**CITY OF SEATTLE
ANALYSIS, RECOMMENDATION AND DETERMINATION OF
THE DIRECTOR OF THE DEPARTMENT OF PLANNING AND DEVELOPMENT**

Application Number: 3007521
Applicant Name: Seattle Children's Hospital
Address of Proposal: 4800 Sand Point Way NE

City Council Action: Approval of a new Major Institution Master Plan for Seattle Children's Hospital.

Figure 2. Proposed phasing (Final Master Plan pg 67)

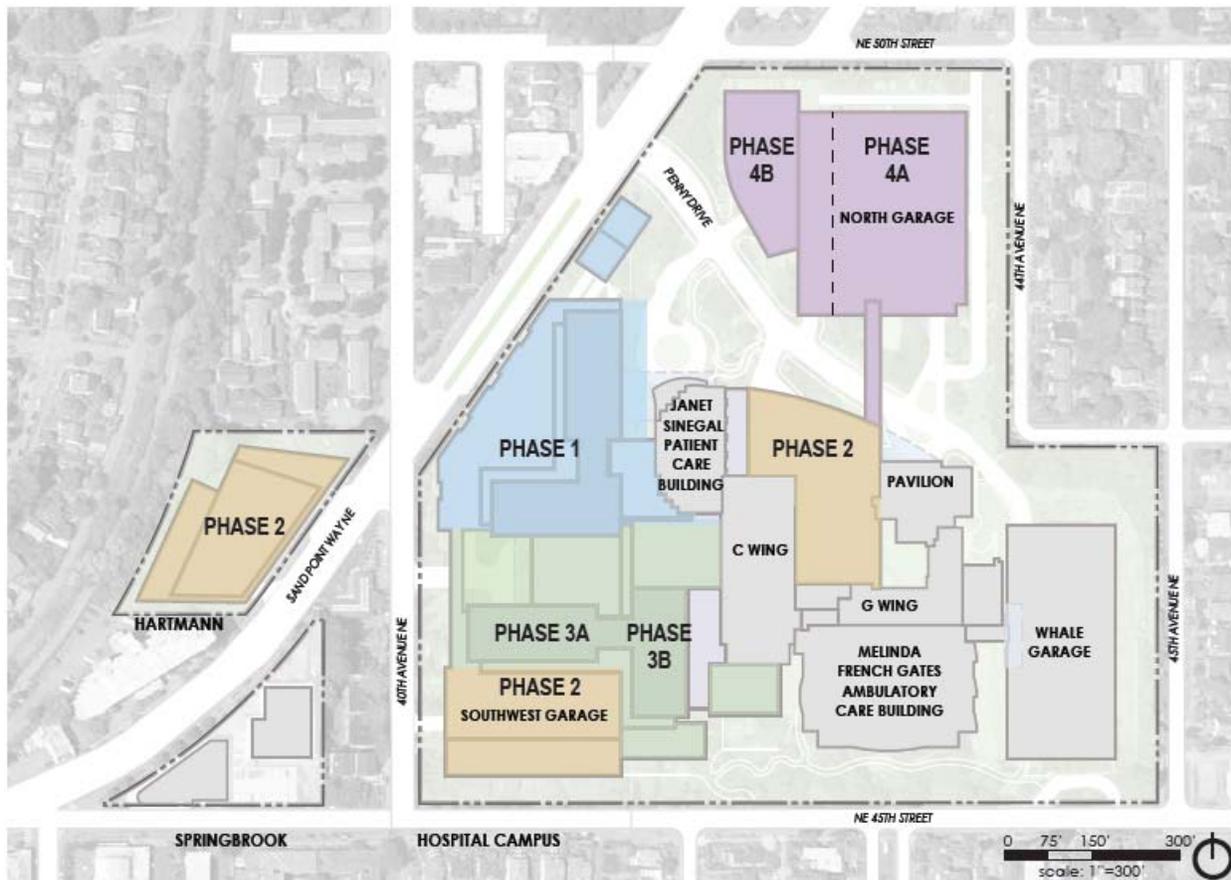
Figure 2 depicts the Final Master Plan's proposed phases. Children's proposes Phase 1 (planned development) to occur between first quarter, 2010 and fourth quarter, 2012. Future phases are potential development, and their timeframes are subject to increased variability, reflecting future uncertainties such as funding and demand. Children's projects Phases 2, 3 and 4 to occur as follows:

The FEIS addresses phasing in Section 2.7 on pages 2-22 through 2-30. The Final Master Plan identifies project phases in Figure 47 on page 66. The FEIS projects construction of Phase 1 to occur between the first quarter of 2010 and the fourth quarter of 2012. The anticipated construction schedules for the potential physical development are Phase 2, fourth quarter 2013 to fourth quarter 2016, Phase 3 in two subphases, second quarter 2017 to fourth quarter 2019 and first quarter 2022 to fourth quarter 2024, and Phase 4, second quarter 2025 to fourth quarter 2027.

Figure 3. Proposed zoning and Major Institution Overlay (Final Master Plan pg 65)

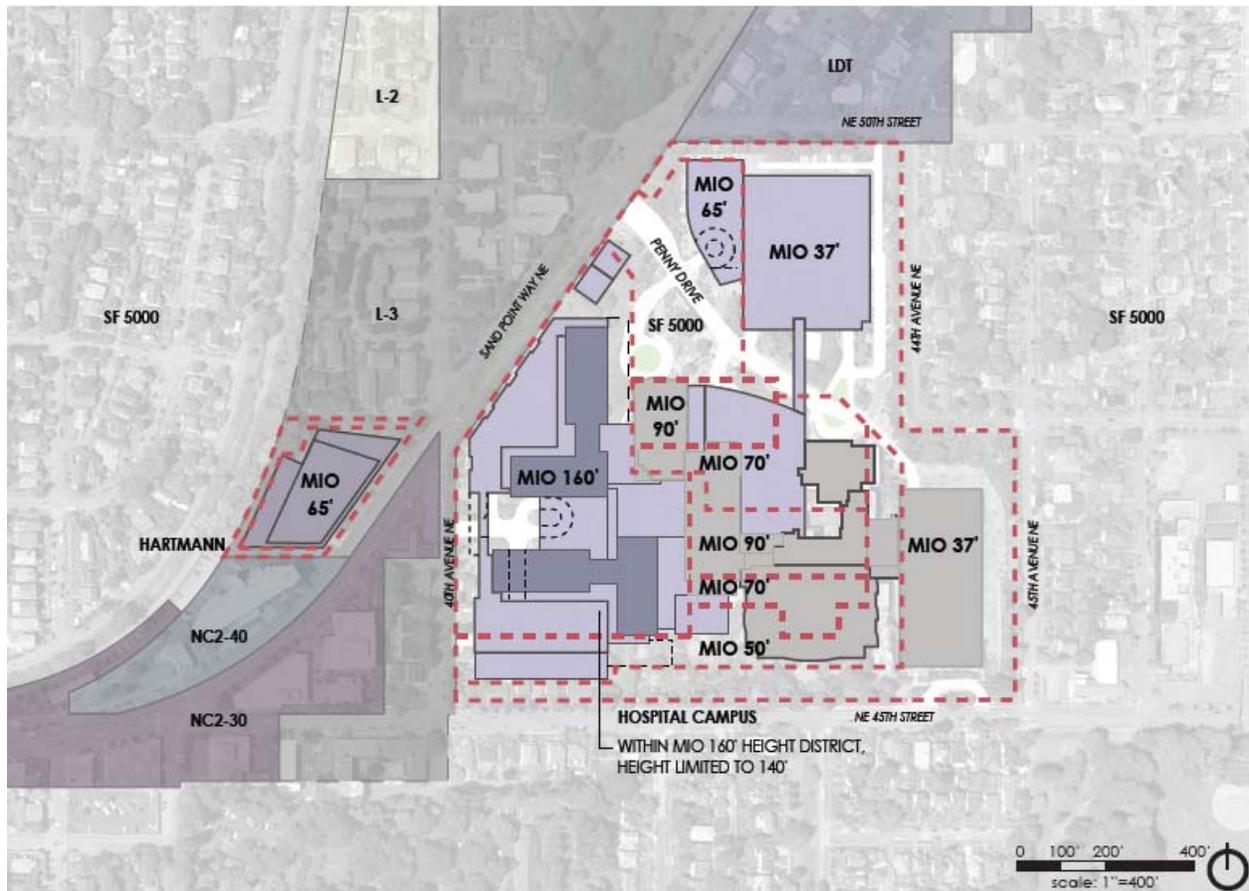
The Final Master Plan involves expansion of the MIO boundary to include the Laurelton Terrace site (Area A) and the Hartmann Property (Area B), as depicted in Figure 1. Expansion also involves increased height limits on the expansion sites and on portions of the existing campus.

The Final Master Plan shows the proposed MIO boundary changes in Figure 46 on page 65. The proposed overlay zoning changes are as follows (see also Figure 3):

The proposed height limit of Area A (Laurelton Terrace site) is 160' for the majority of the site, with a portion designated as MIO 50 in conformance with a contiguous MIO 50 district from the existing campus, and MIO 37 along the southern boundary. The current MIO heights on the existing campus range from MIO 37 on the north to MIO 70, MIO 90, dropping back to MIO 70 and then MIO 50 on the south. The Master Plan proposes to increase height limits to MIO 65 on the north, MIO 90, MIO 160 toward the west and center of the expanded campus, and MIO 50 on the south (see Figure 3 on page 45). The underlying residential Lowrise 3 zone allows heights up to 30', with increases allowed for pitched roofs or other rooftop features. The proposed MIO 37 is consistent with the allowed heights of both the lowrise zoning located to the west of the site, and the single family zoning located to the south of the site. The proposed 50' and 160' MIO height limits are substantially higher than allowed heights of the underlying zone, but are consistent with the adjacent existing MIO districts.
